Westinghouse BWR ECCS Evaluation Model:
Supplement 5 – Application to the ABWR

May 2014

SUBJECT: FINAL SAFETY EVALUATION FOR SOUTH TEXAS PROJECT WCAP-17116-P,
“WESTINGHOUSE BWR ECCS EVALUATION MODEL: SUPPLEMENT 5 –
APPLICATION TO ABWR”

Figure 4-41 Comparison DLB to RHRSLB – Dome Pressure and System Mass

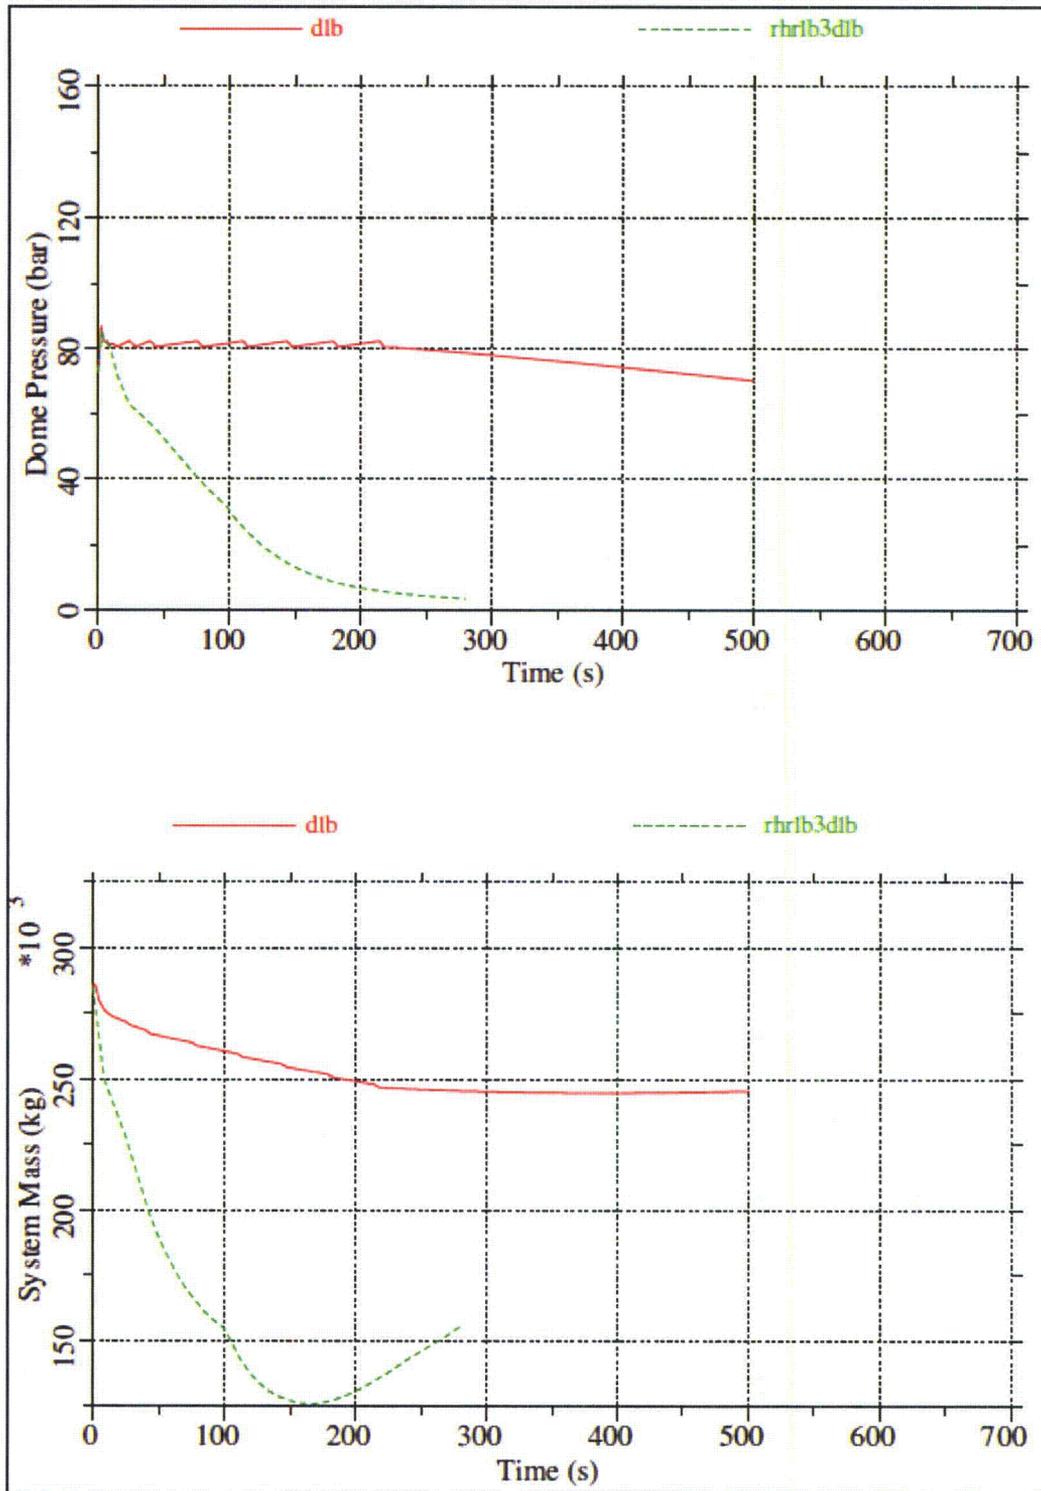
- The analyses supporting Section 4.5.6.1 “Drain Line Break Results” were revised to correct the number of credited HPCF pumps. Table 4-7 and Figure 4-41 of this report have been corrected, as well as Summary Table 4-9 and Summary Figure 4-46. See the response to RAI 32 Supplement 2, for further discussion.

Figure 4-46 Summary of Minimum Inventory Results vs. Break Size

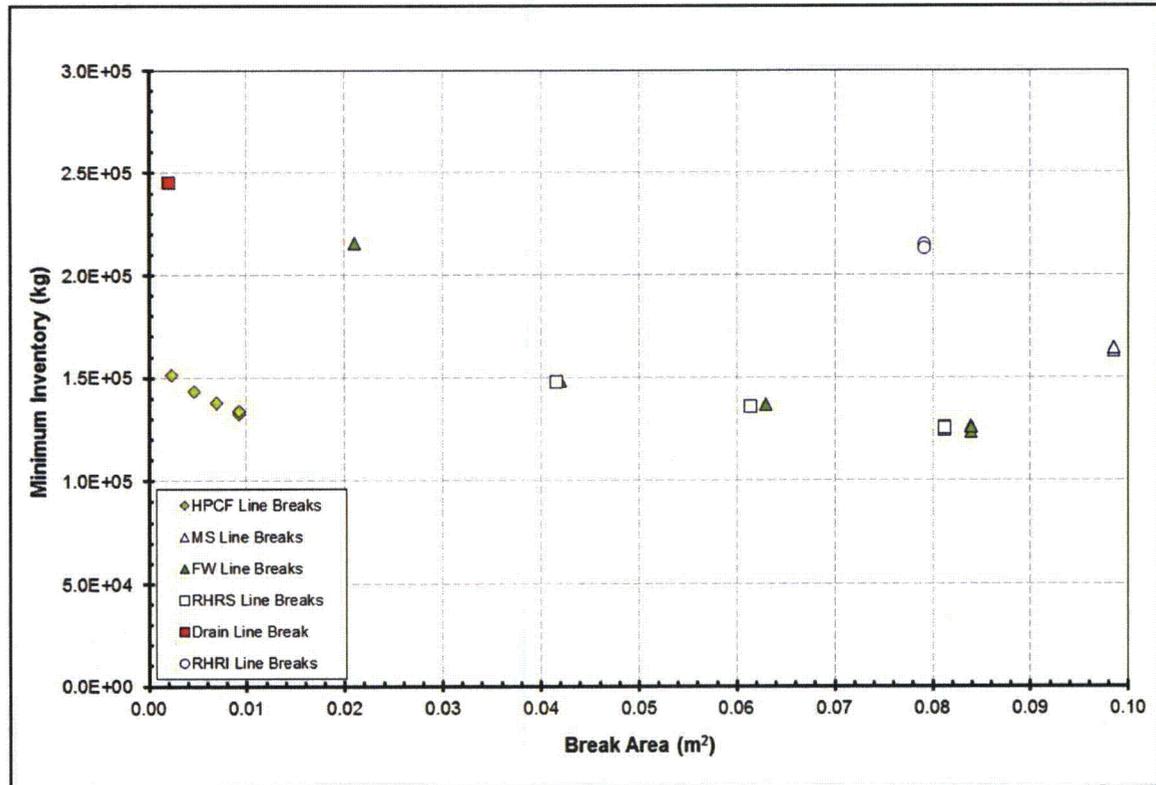
- The analyses supporting Section 4.5.4.1 “RHR Suction Line Break Results” were revised to correct the number of credited HPCF pumps. Table 4-5 of this report has been corrected, as well as Summary Table 4-9 and Summary Figure 4-46. See the response to RAI 32 Supplement 2, for further discussion.

Figure 1-2 - Effect of Downcomer Level Tracking on Dome Pressure and Break Flow (Feedwater Line Break)

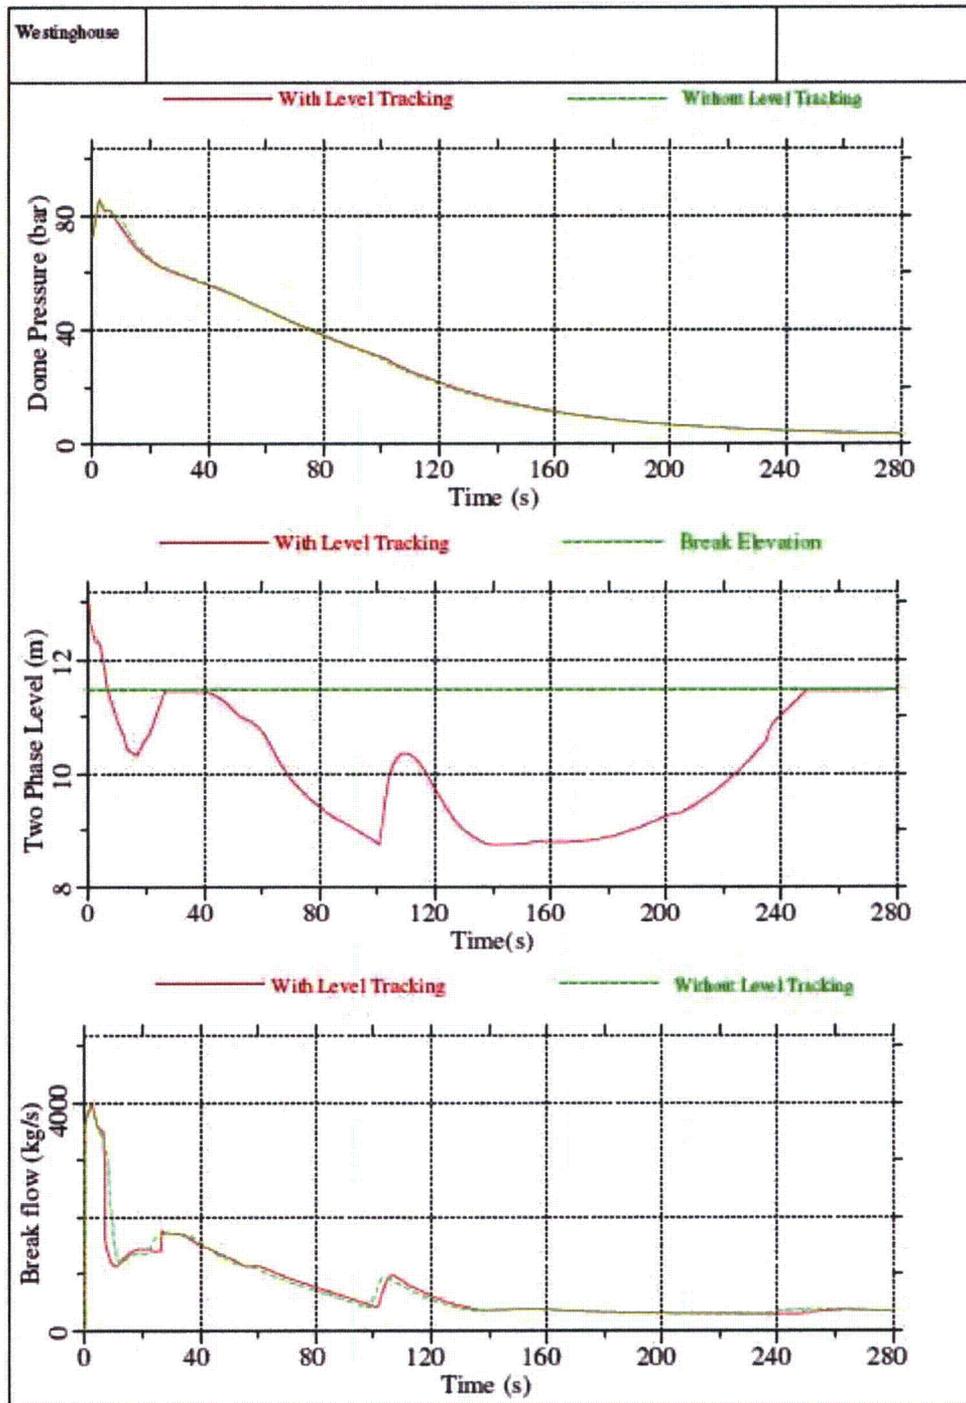
Figure 1-2 shows the dome pressure comparison between the cases, and it shows no significant change in the pressure response when the level tracking is turned off. Figure 1-2 also compares the downcomer two-phase level for the base case and the break flows. It shows that the break flow changes are more responsive when the two-phase level elevation drops below the elevation of the break location.

Figure 1-3 - Effect of Downcomer Level Tracking on Clad Temperatures and System Inventory (Feedwater Line Break)

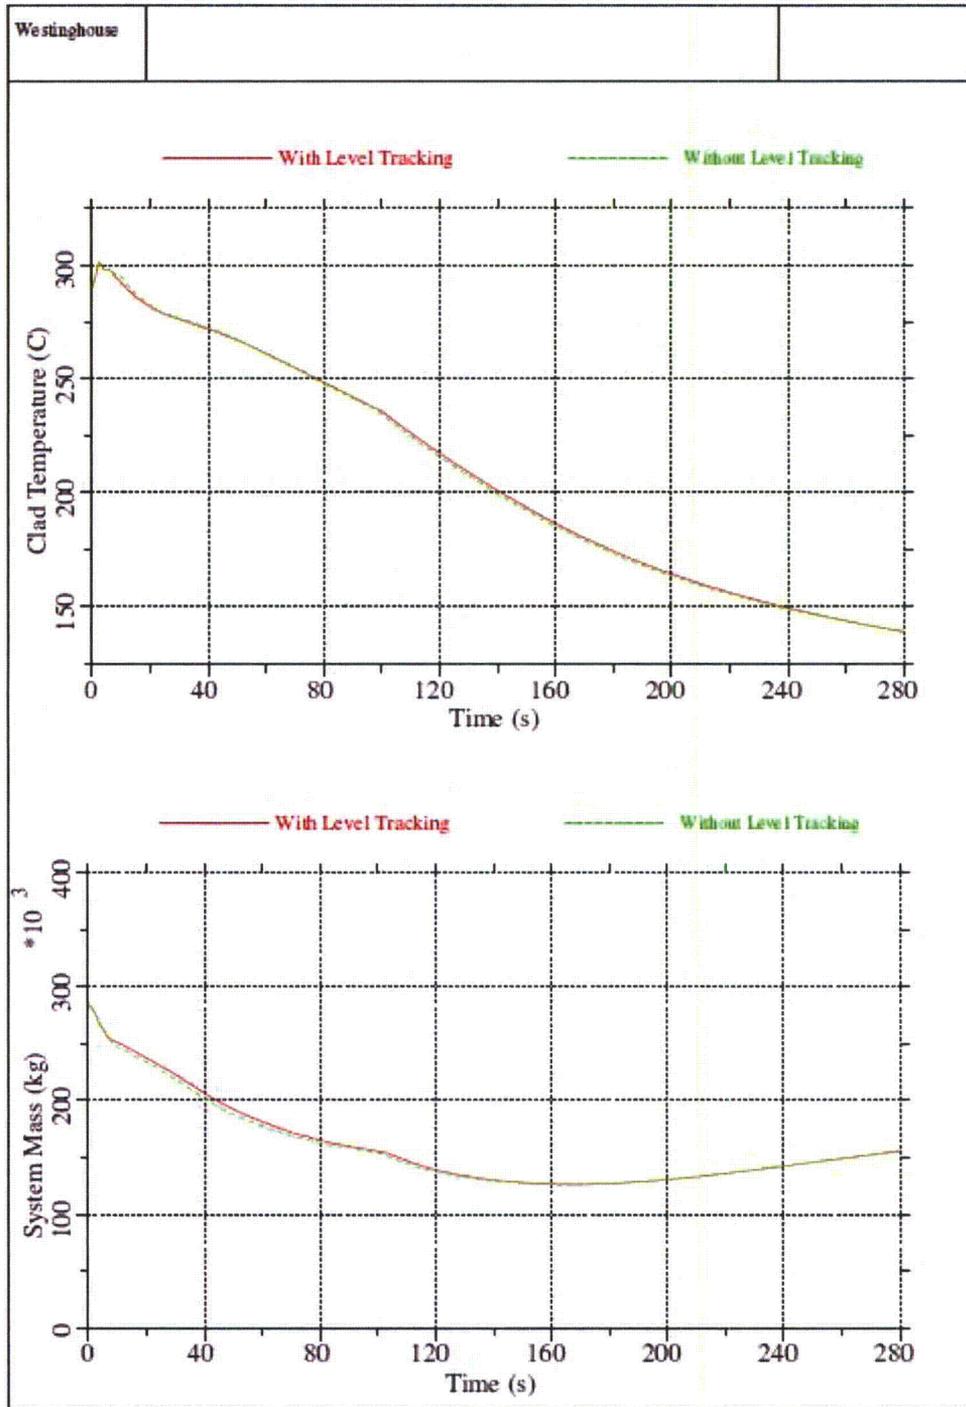
The clad temperatures of the upper most heated node are compared in Figure 1-3. It confirms that the use of level tracking has no discernable effect on clad temperature, and that the core does not heat up during the transient, with and without the level tracking. The second plot in Figure 1-3 compares the total system masses. It shows that the time dependent system mass remains the same, with and without level tracking. The minimum system inventory decreases from 126.5E3 kg to 126.2E3 kg when the level tracking is off.

Figure 2-1 – PCT for Different Feedwater Coast Down Times

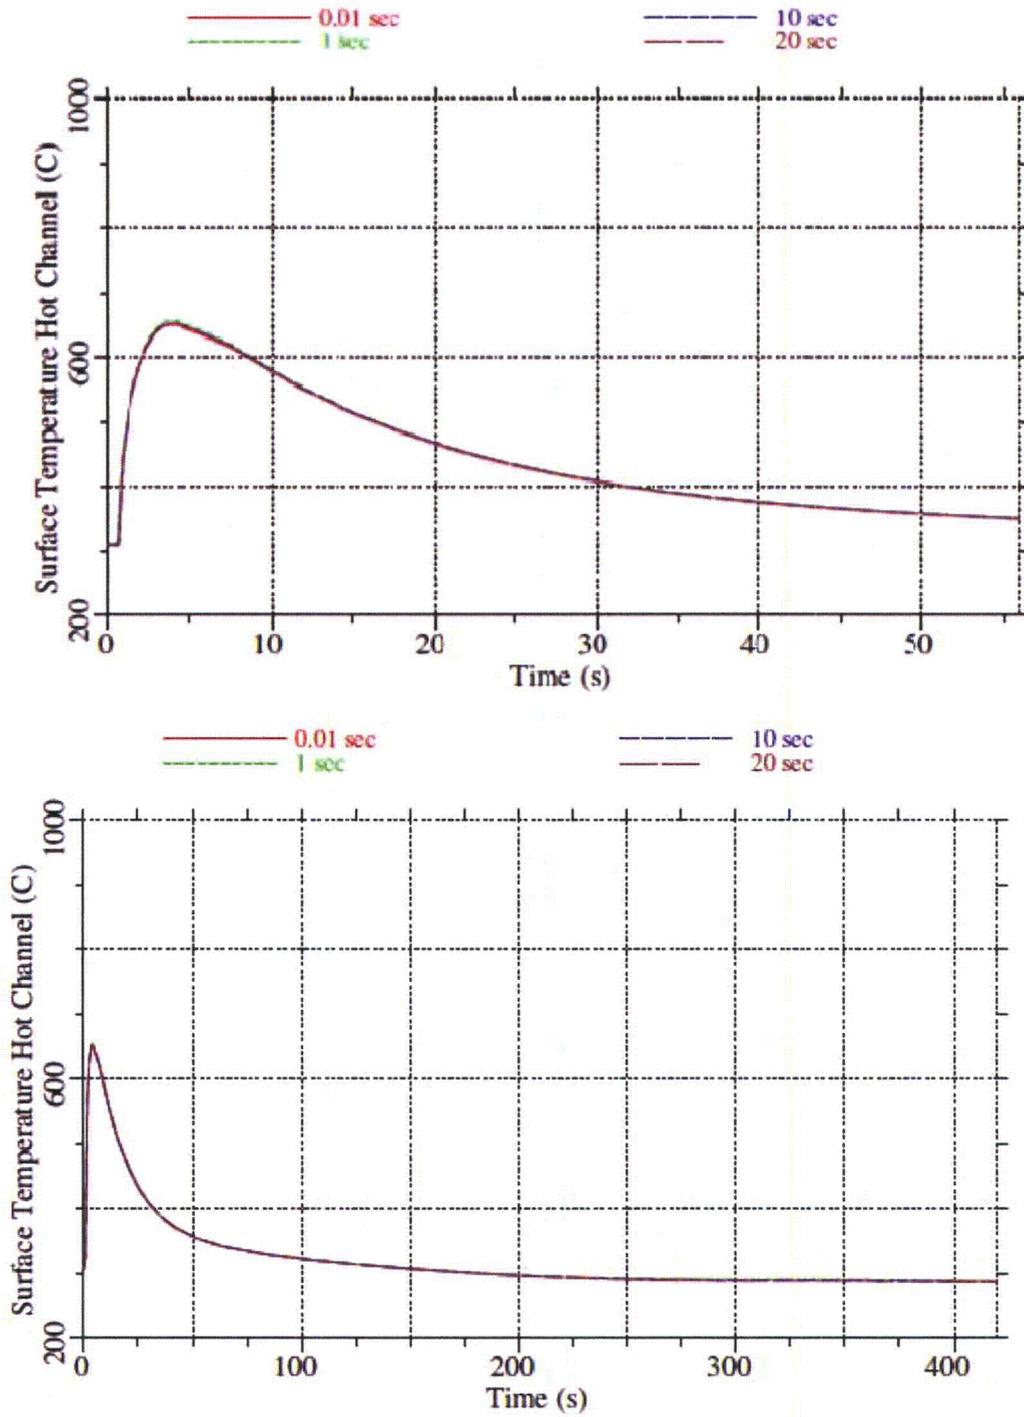
To investigate the effect of feedwater coastdown time on the calculated Peak Clad Temperature (PCT), additional GOBLIN runs were performed with feedwater coastdown times of 0.01, 10 and 20 seconds. These calculations showed no difference in the calculated PCT for hot or average channels when varying the assumed feedwater coastdown time. Because the PCT occurs so early in the accident sequence, continued flow from feedwater pumps is unlikely to have a significant effect on the PCT. Figure 2-1, below, shows clad temperature for the limiting elevation of the hot channel as a function of feedwater coastdown time. Note that the curves for the four coastdown times are superimposed on top of each other.

These calculations conclude that feedwater coastdown times that are longer than the fast (1s) coast down time do not have an effect on the PCT.

Figure 3-1 Variation of Maximum Cladding Temperature During Partial Core Uncovery with Respect to Bundle Peaking Factor

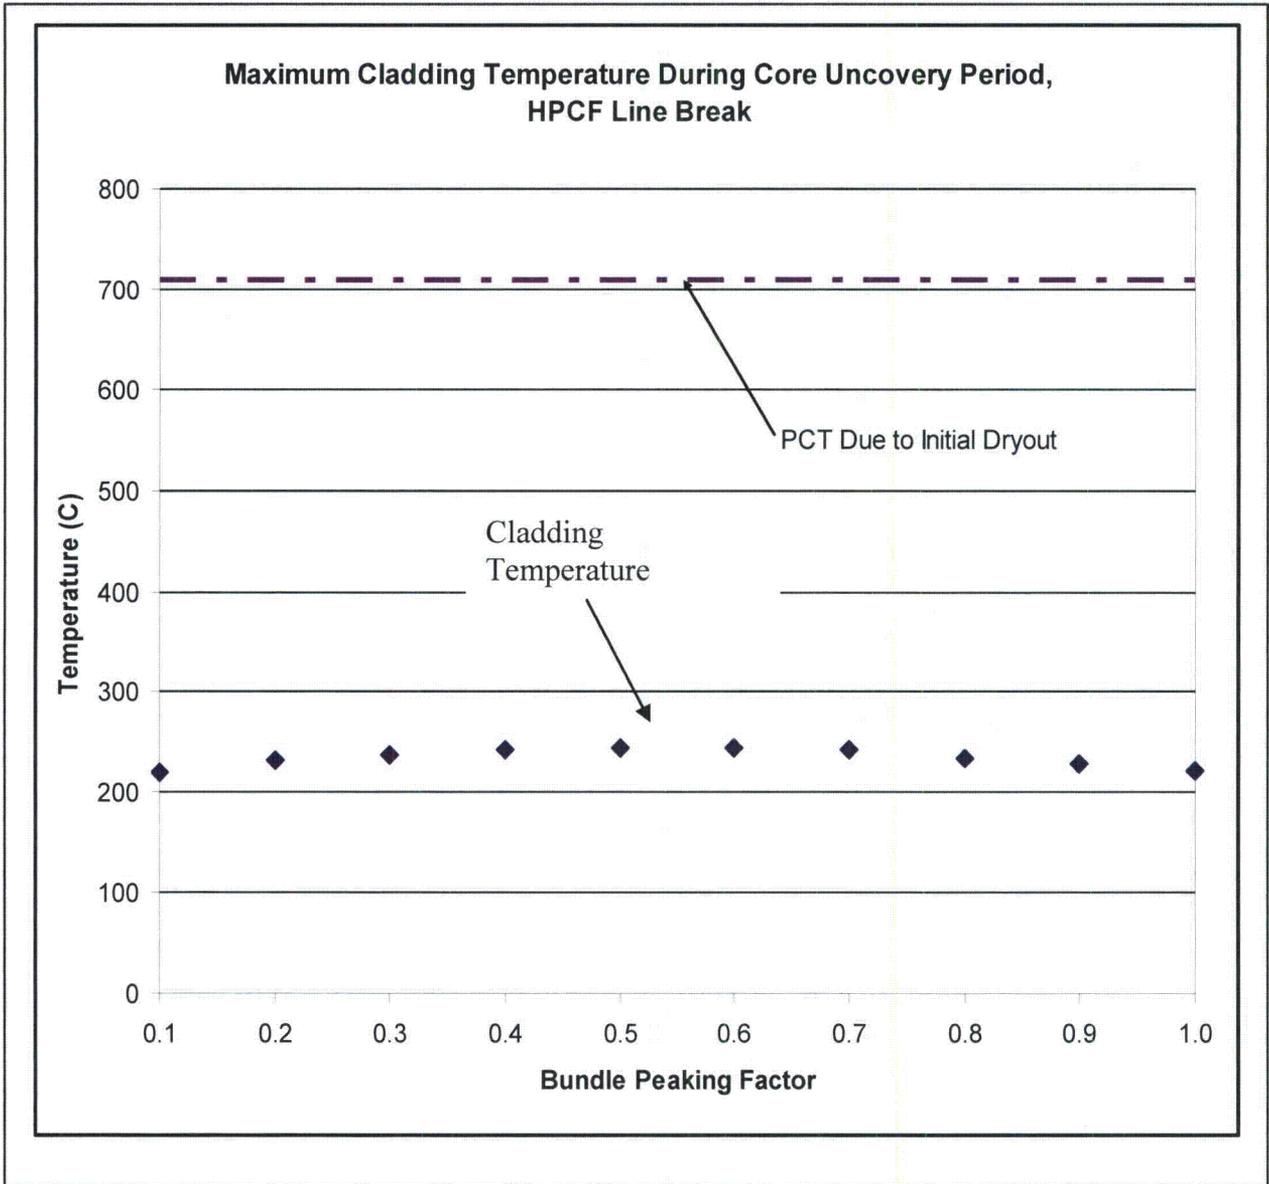
For each power level, the GOBLIN maximum cladding temperature during the core partial uncover period after the automatic depressurization system (ADS) is actuated, is shown in Figure 3-1. The GOBLIN peak cladding temperature (PCT) due to the initial dryout is also included for comparison purposes.

The results of the expanded study, as shown in Figure 3-1, show that the maximum cladding temperature during the partial uncover is well below the PCT during the initial early dryout time, and the maximum cladding temperature is also a well behaved function of bundle power. Figure 3-1 also shows that the maximum cladding temperatures for these additional assumed bundle peaking factors are not significantly higher than the ones documented in the sensitivity analysis in WCAP-17116-P. Therefore, explicit modeling of lower power assemblies is not warranted.

Figure 11-1 Break area for the RIP failure

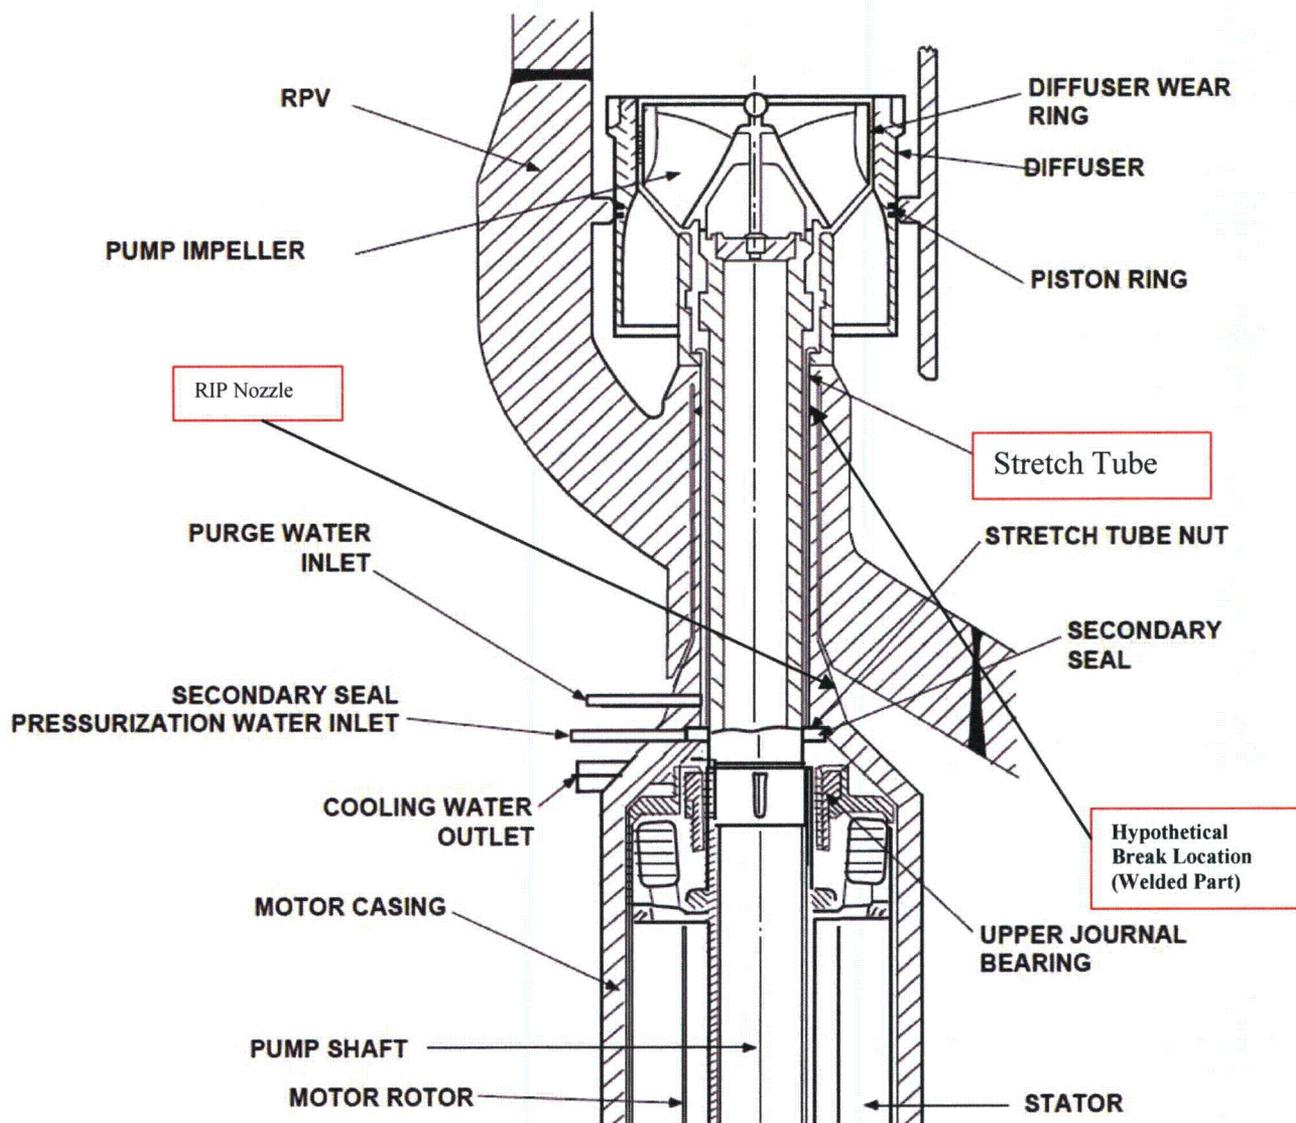
The break area for the RIP failure, which is equivalent to a gap between the stretch tube and the RIP nozzle (See Figure 11-1), is less than the design basis BDLB area (20 cm²).
